## COMMUNITY DESIGN REVIEW BOARD STAFF REPORT

**AGENDA ITEM:** Design Review Resolution, Multifamily Residential Apartment Building, 1375 Frost Avenue East

**Engineering Plan Review**

# Environmental Review

NORTH BUILDING ELEVATION  
1/8" = 1'-0"

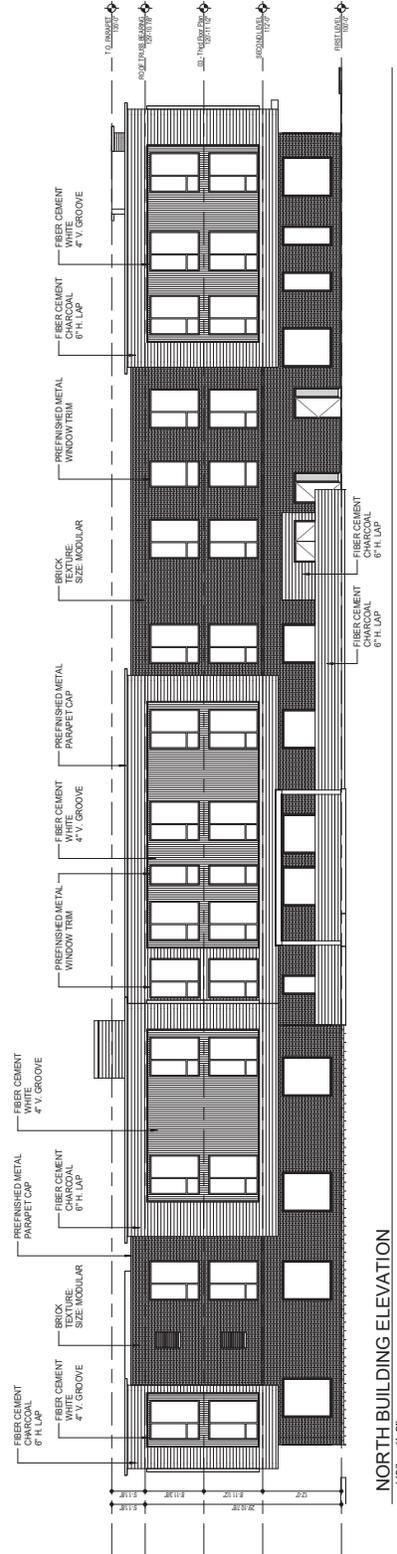
However, the elevations do not include the percentages for each primary, secondary, and accent material. The applicant must submit updated elevations illustrating the percentages for each material before obtaining a building permit.

Staff recommends that the applicant update the plan to shorten and articulate the façade along the east side of the building, specifically, the section that is 74 feet in length. If the board agrees with this recommendation, the applicant must submit an updated colored site perspective of the elevation illustrating the proposed articulation and shorter wall lengths.

- i. The applicant shall submit updated elevations and perspective renderings: the updated plans must identify the percentages of each proposed building material for all sides of the building. The renderings must illustrate the segment length of the building façade along the east side of the building.
